Docket Number:	12-AFC-03
Project Title:	Redondo Beach Energy Project
TN #:	201924
Document Title:	Redondo Beach Energy Project's Responses to CEC Staff Data Requests 72, Set 4.
Description:	N/A
Filer:	Sarah Madams
Organization:	CH2M HILL
Submitter Role:	Applicant Consultant
Submission Date:	3/26/2014 10:01:39 AM
Docketed Date:	3/26/2014

Subject: Redondo Beach Energy Project (12-AFC-03)
Data Response Set 4 – Responses to CEC Staff Data Requests 72

Redondo Beach Energy Project

Data Responses, Set 4

Figure DR 72-1
Noise Model Results –
Estimated RBEP Noise Level
Contours (Existing Ambient
Noise not included)
 AES Redondo Beach Energy Project
 Redondo Beach, California

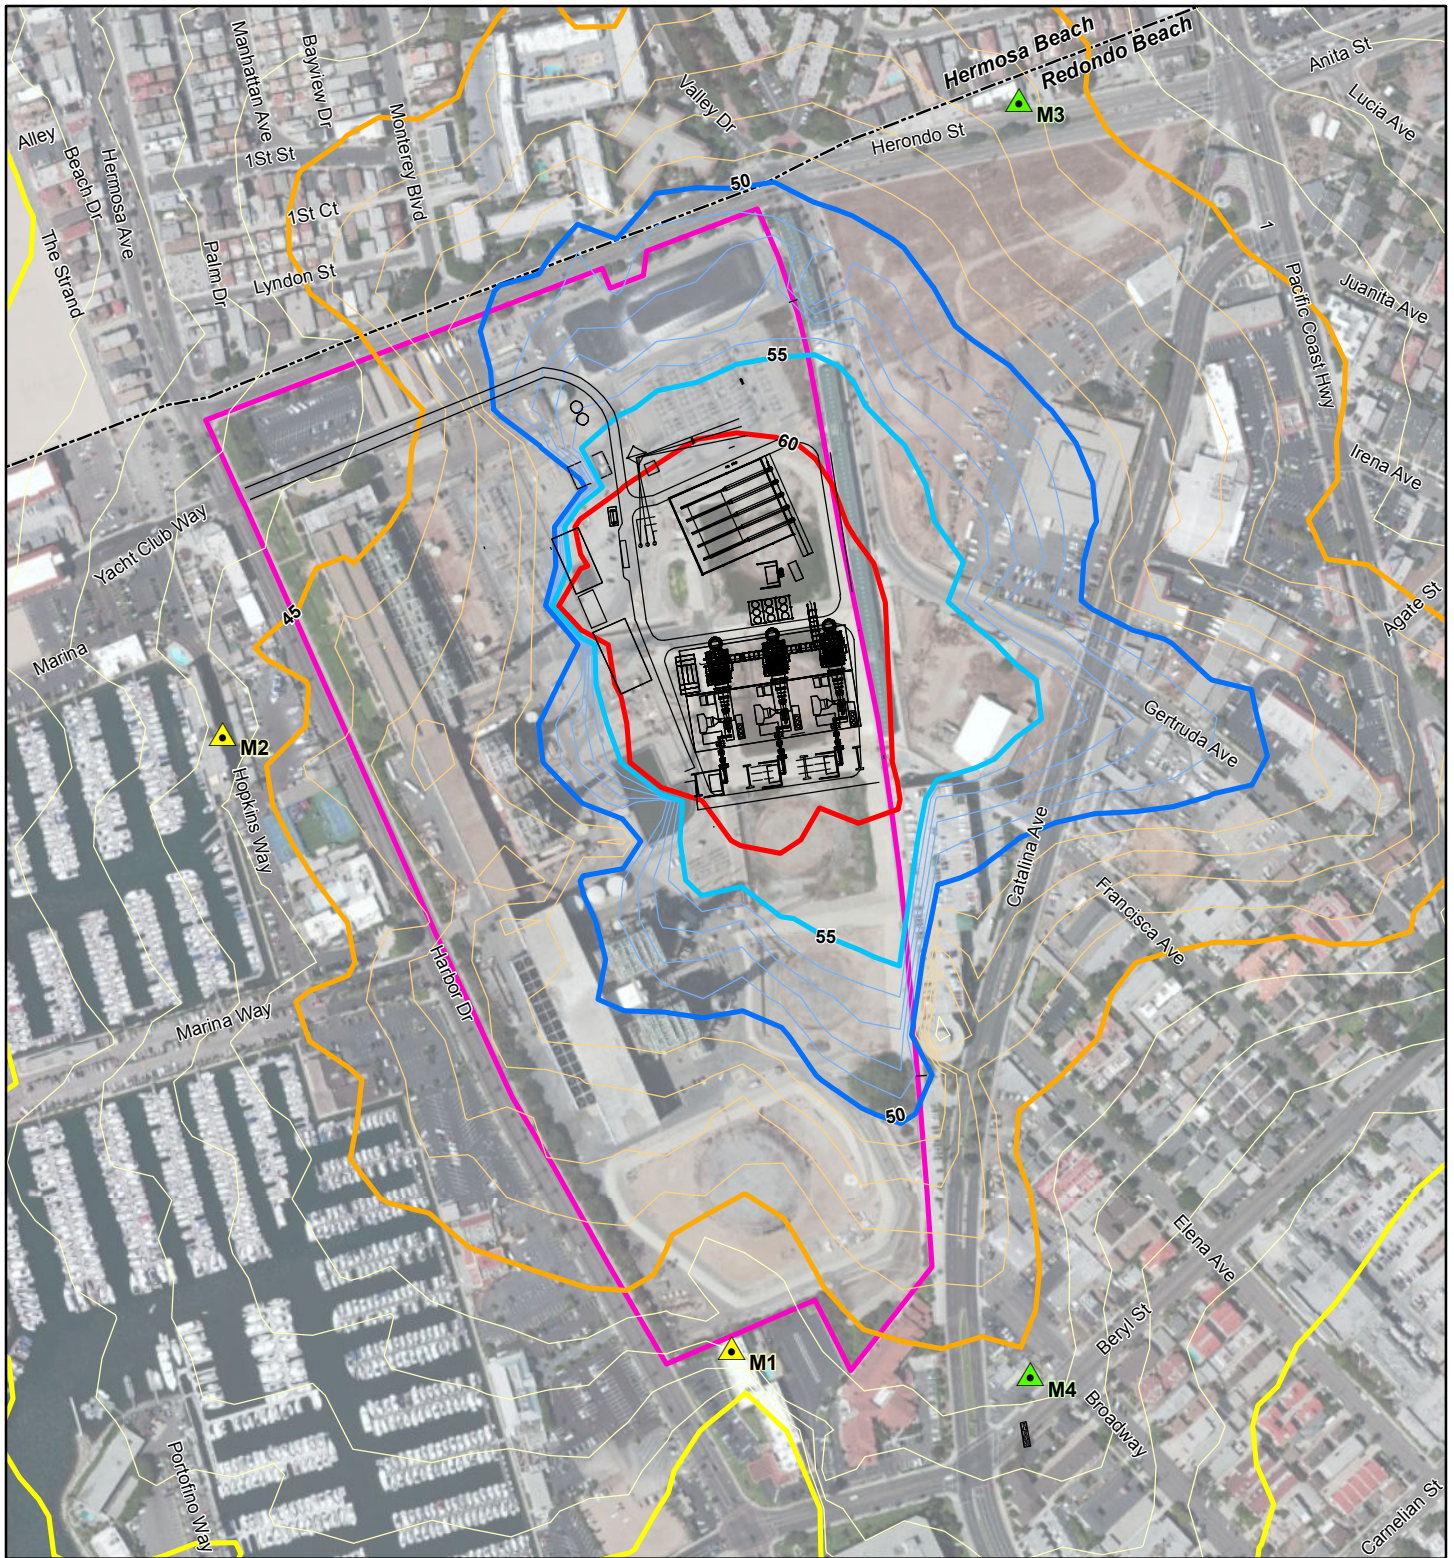
72. Please provide a sound level contour map that shows the expected operational noise levels from the proposed project alone at receptors M3 and M4.

Response: Figure DR72-1 identifies the expected noise level contours from the Redondo Beach Energy Project, based on current knowledge of the types, locations, and source levels of the equipment to be used during operations. The figure also shows the locations of the four noise monitoring locations. Noise levels at M1 and M2 were measured in 2011. Noise levels at M3 and M4 are currently being measured. The noise level contours in Figure DR72-1 represents only the noise from the RBEP and do not include non-RBEP noise or the barrier effect of buildings offsite. Therefore, the estimated noise levels for receptors farther away from the first row of buildings depicted in Figure DR 72-1 are conservatively high.

It should be noted that the contours in Figure DR72-1 represent the best estimate based on current information. The final design will incorporate all noise control measures required to ensure compliance with the applicable LORS.
